**Project Name:** Forest Avenue - 326; Retail And Parking; Oakhurst Properties.  
Applicant.  
**Project ID:** 10-79900001  
**Project Address:** 326 FOREST AVENUE  
**Planner:** Shukria Wiar

On April 15, 2010, the Portland Planning Authority approved a minor site plan for renovation of an existing building and a new parking lot at 326 Forest Avenue as submitted by the Applicant and shown on the approved plan prepared by BH2M, Inc. with a revision date of 02.08.2010 with the following conditions below.

I have reviewed the February 8, 2010 site plan prepared by BH2M Engineers and Surveyors and offer the following preliminary comments.

Woodard & Curran has reviewed the Minor Site Plan Application for 326 Forest Ave. The project involves the demolition of a portion of an existing building, the rehabilitation of the remaining building, and the construction of parking and landscaping.

From drawing A1.1 ↑ CWS

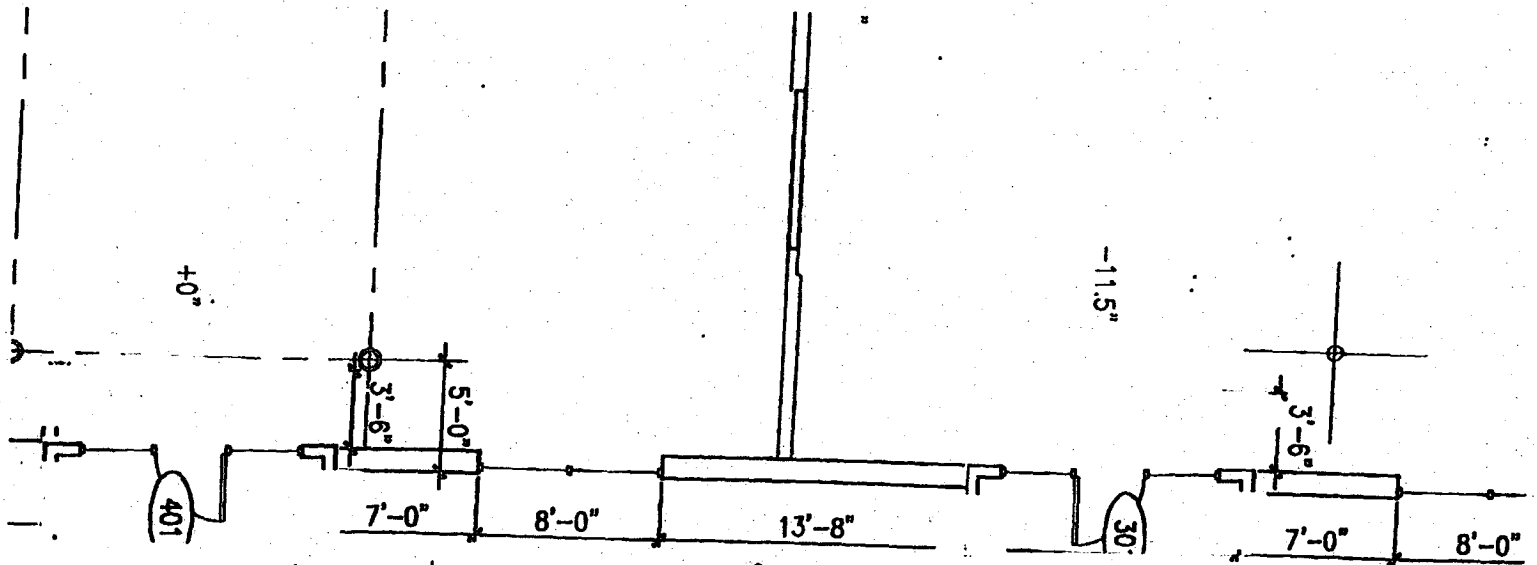
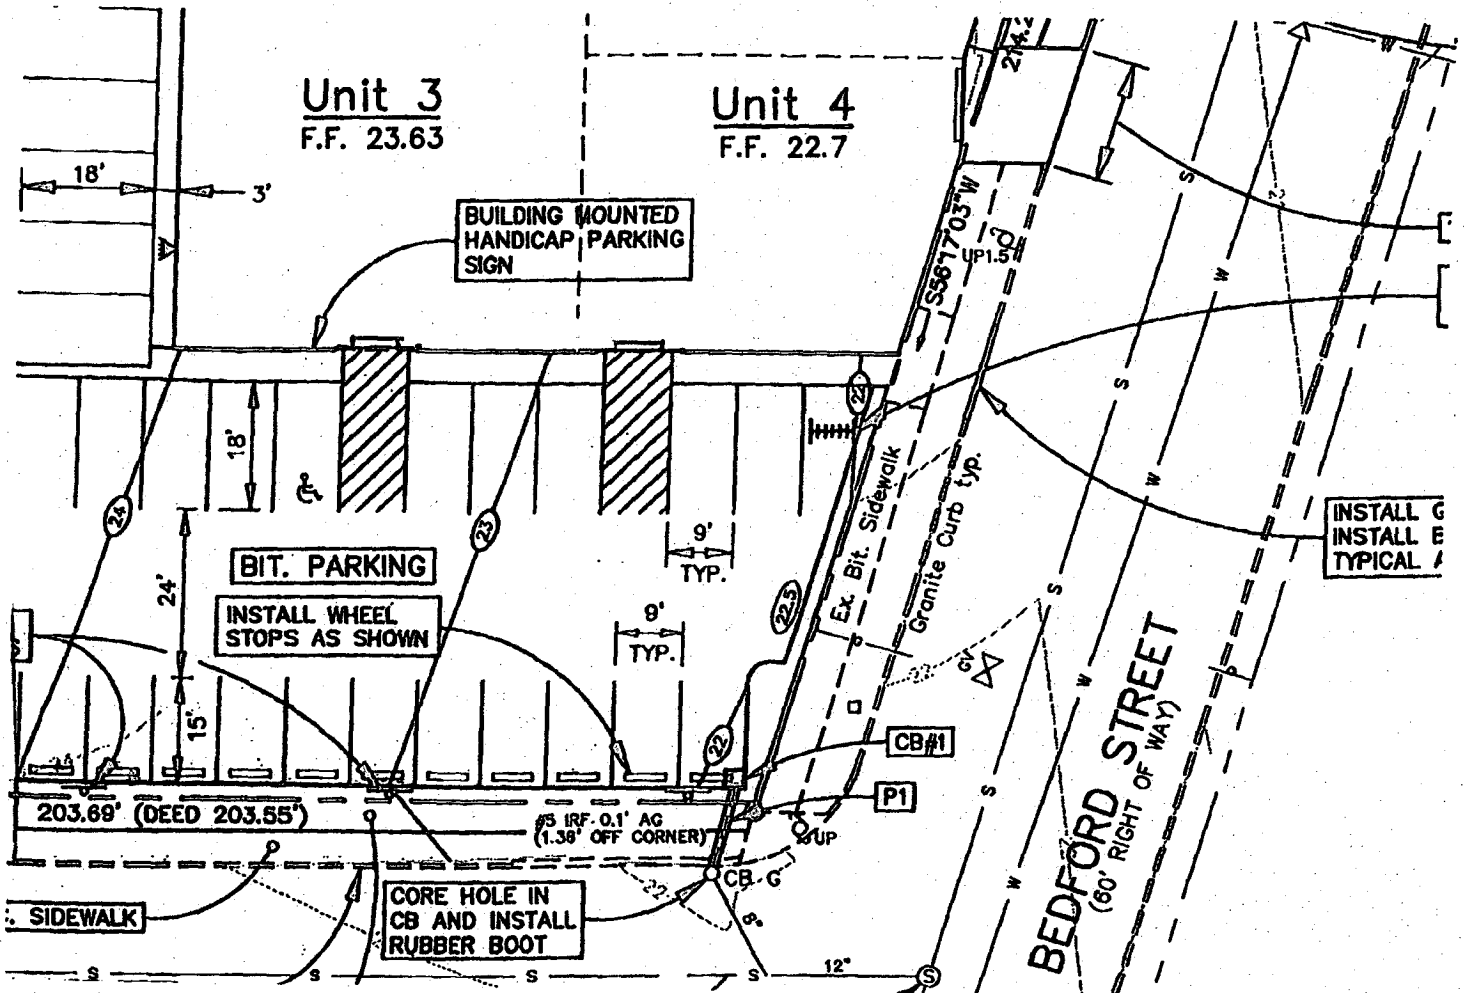
The proposed change to eliminate the vestibule entrances at the rear portion of the building at 326 Forest Ave to flush entrances, as described below (see your email from July 9th) and shown on the attached drawings, has been approved by the Planning Authority.

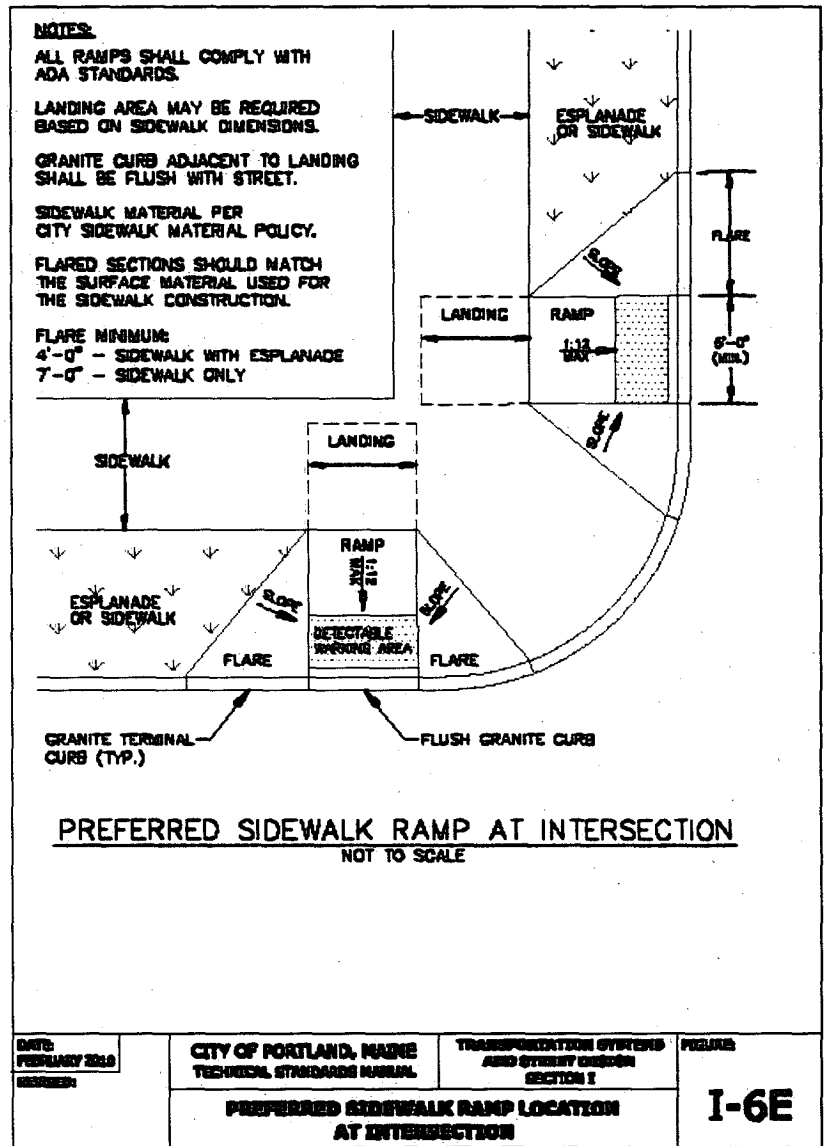
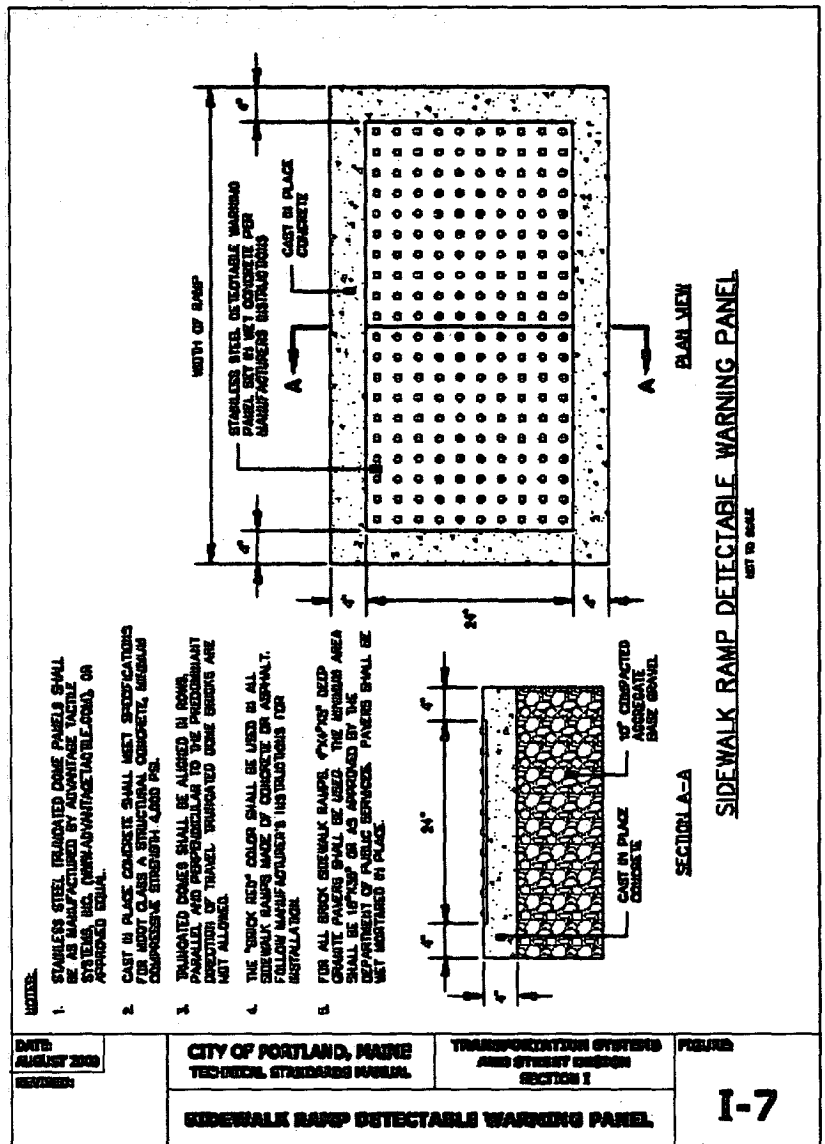
4. The sidewalk material policy for this area of Portland including Bedford and Durham Street is concrete; therefore the sidewalks on both streets shall be constructed in concrete. The applicant has indicated the intent to install a proposed catchbasin (three foot sump) in the corner of the new parking lot and core drill into the City's existing catchbasin. The applicant has also indicated the intent to reinstall vertical granite curbing on Durham Street. The City request that the slope faced curbing on Durham Street is replaced with vertical curbing. The City does have some stockpiled curbing which may be used to fill this void at minimal cost. Please contact Marc Spiller (756-8162) of this department for details. As part of this work the City is requesting that the

sidewalk ramp be reconstructed as shown in the following figure with pedestrian traffic being directed perpendicular to Durham Street and not diagonally into Bedford Street.

Please note revised color for the tactile warning strip is now "Yellow" and not "Brick Red" as stated above. In addition, Bedford Street is currently under a paving moratorium until August of 2013. The City would like the applicant to close all curb cuts on Bedford Street, not just the one indicated on the plans. As stated above, the sidewalks on both Bedford and Durham Street shall be constructed with concrete. However, since Bedford Street is under a moratorium, this department is agreeable to a Performance Guarantee to complete this work after July of 2013. All granite curb to be installed with be vertical and will match. The sloped with not be reused, this note will be changed on the plans. As previously noted the sidewalk

on Durham Street will be constructed in concrete and noted on the plans as such. The sidewalk along Bedford Street is not going to be disturbed (curbs are next to an existing esplanade) and are in good shape so we would request to leave them as is. The note on replacing that small section will be removed and existing concrete in this area will remain. As far as the ramp this is outside the scope of work of this job so we would like to leave it as is.
